**CITY OF LOS ANGELES**  
INTER-DEPARTMENTAL CORRESPONDENCE

3440 Wilshire Boulevard  
DOT Case No. CEN19-48798

Subject: **ADDENDUM TO THE TRANSPORTATION IMPACT ANALYSIS FOR THE PROPOSED MIXED-USE PROJECT AT 3440 WILSHIRE BOULEVARD**

Subject: **TRANSPORTATION ANALYSIS FOR THE PROPOSED MIXED-USE PROJECT LOCATED AT 3440 WILSHIRE BOULEVARD**

Figure 1  
Revised Site Plan

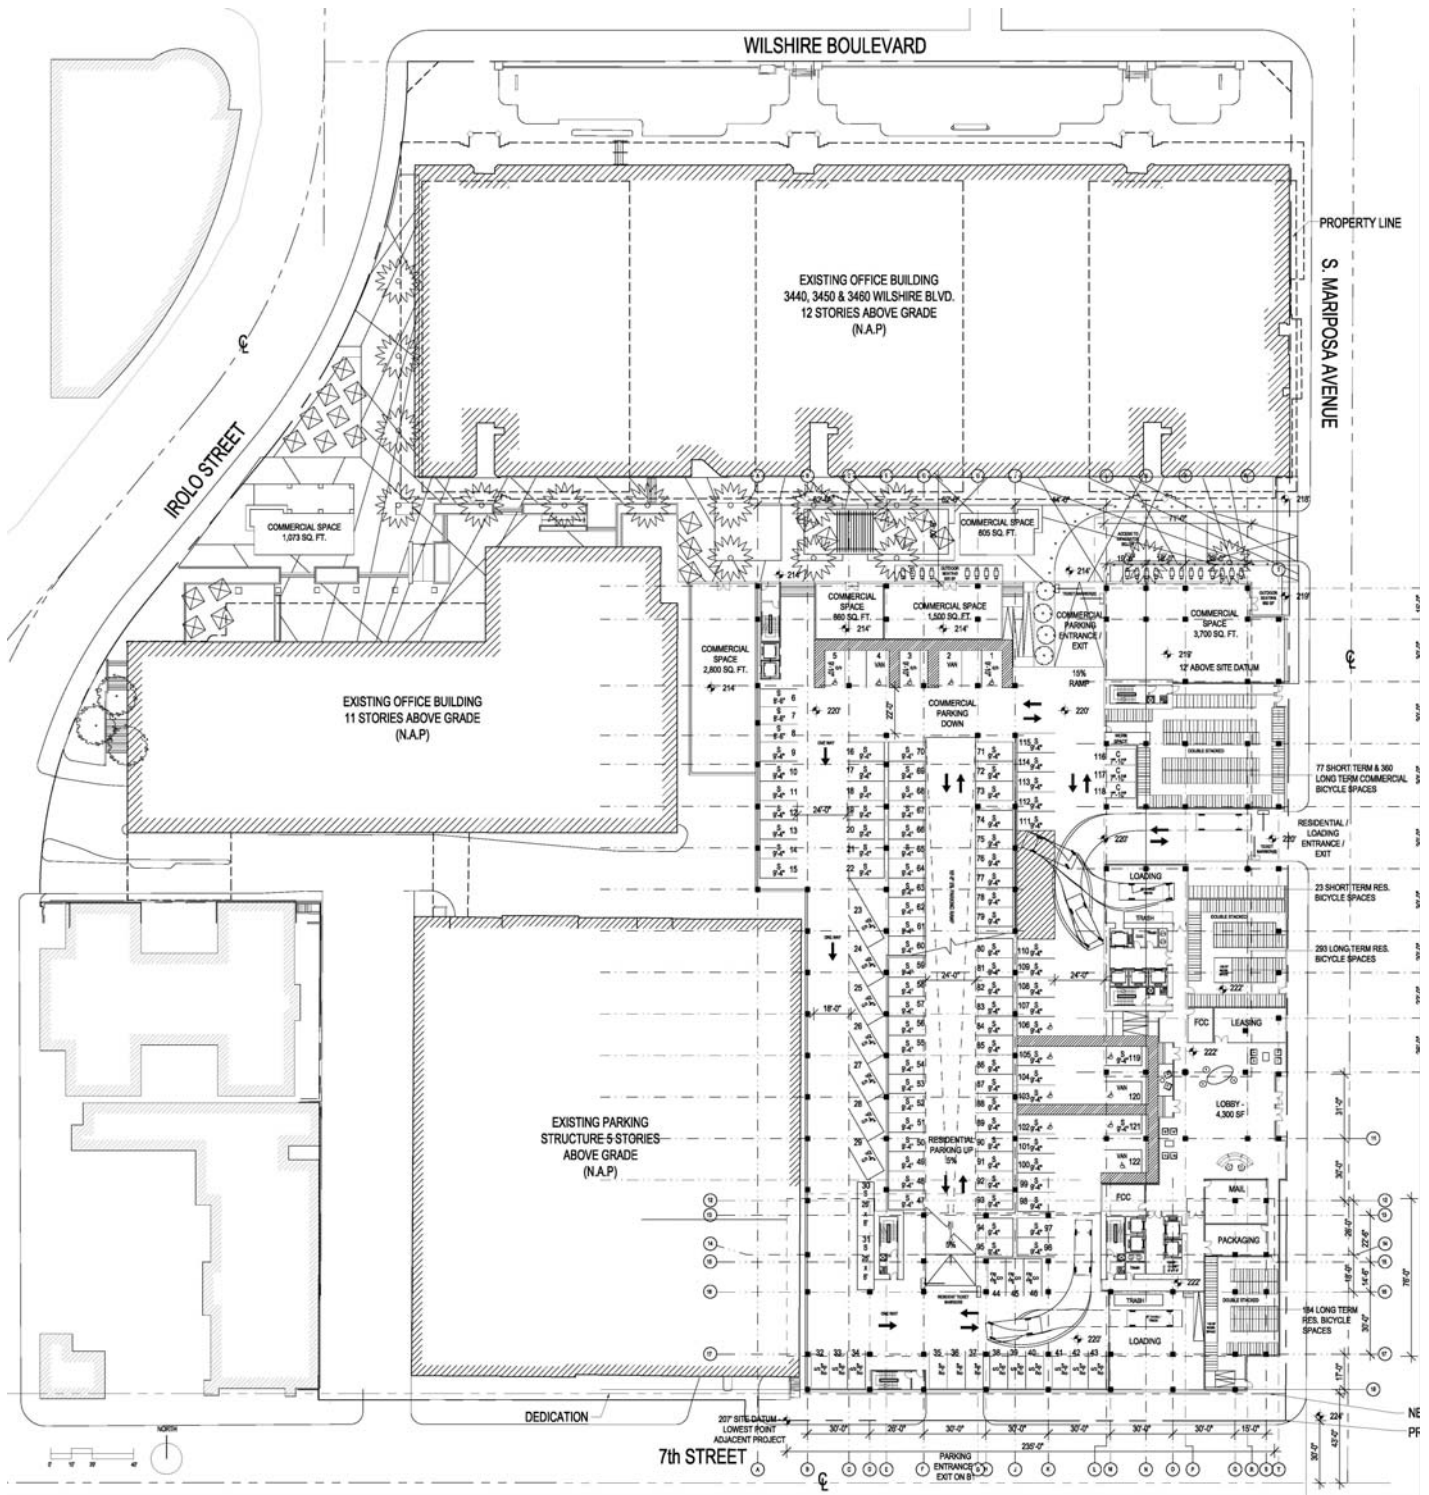
The original project at 3440 Wilshire Boulevard proposed 641 multifamily high-rise residential units and 18,454 square feet located. The revised project proposes 640 multifamily high-rise residential units, 5,538 square feet of retail space, 4,600 square feet of high-turnover sit down restaurant, and 2,000 square feet of fast casual restaurant. The revised project level of service table can be found in **Attachment A**. The revised project trip generation table can be found in **Attachment B**. The revised project site plan can be found in **Attachment C**. The original project's level of service table, trip generation table, and site plan can all be found in **Attachment D**. The revised project's access and driveway plan will remain the same as the original project. A table of project land use changes is as follows:

The previous traffic analysis determined that none of the fourteen analyzed intersections would be significantly impacted by project related traffic. The revised is also not expected to result in significant impacts to any of the fourteen intersections. DOT concurs with the addendum that the project's expected impact would be less than significant and no changes to the transportation analysis are required. All of the project requirements that are identified in DOT's October 25, 2018 letter (**Attachment D**) shall remain in effect.

Figure 2A  
Site Plan - Level 1

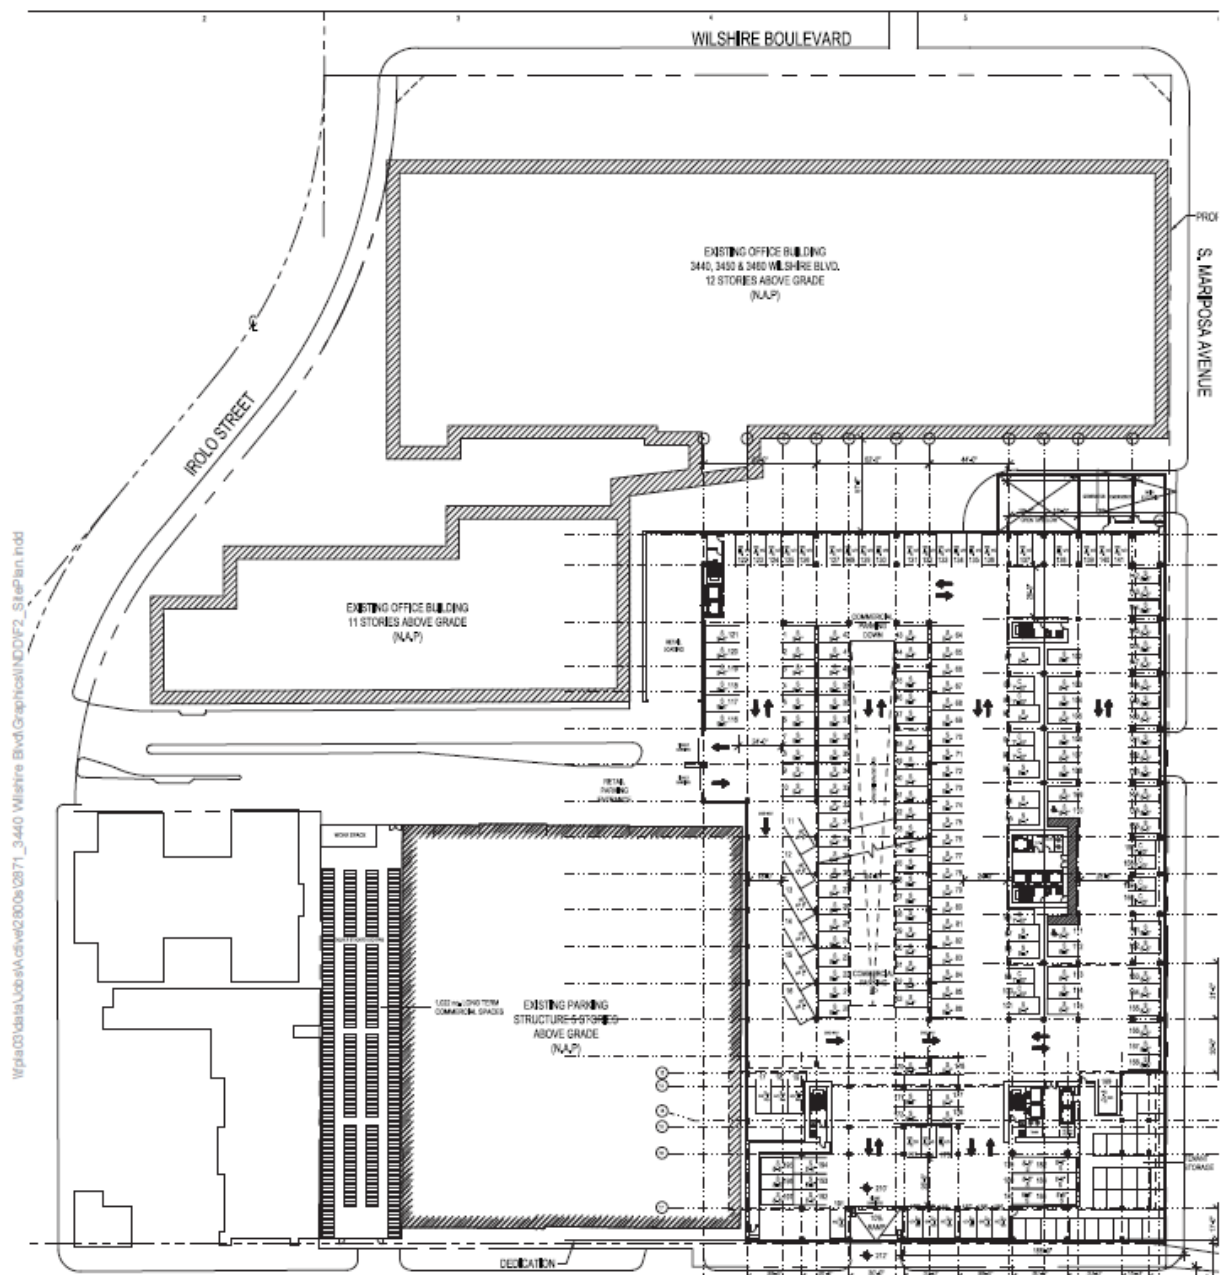
The proposed site plan illustrated in **Attachment 3** is acceptable to DOT; however, review of the study does not constitute approval of the driveway dimensions and internal circulation schemes. Those require separate review and approval and should be coordinated with DOT's Citywide Planning Coordination Section (201 N. Figueroa Street, 5th Floor, Room 550, at 213-482-7024). In order to minimize potential building design changes, the applicant should contact DOT for driveway width and internal circulation requirements so that such traffic flow considerations are designed and incorporated early into the building and parking layout plans. All new driveways should be Case 2 driveways and any security gates should be a minimum 20 feet from the property line. All truck loading and unloading should take place on site with no vehicles backing into the project via any of the project driveways.
